Access Compliance Report Public Rights-of-Way (Pedestrian Signals)

Main Street: **CHIQUITA_CANYON_DR** Cross Street: **AIROSO_ST** Location: **NW**

ADA ID: **SGRK211130125829** Signal Type: **One Push Button-Non APS** Overall Compliance: **No** Severity Scores: **BTN 1: 35** **BTN 2: N/A** **No BTN: N/A**

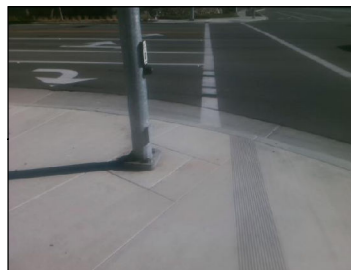
OC Std/PROW: R404.2, R404.3, MUTCD 4e.08

Possible Solutions: Replace Signal Push Button With APS Button. Remove and Replace Clear Space.
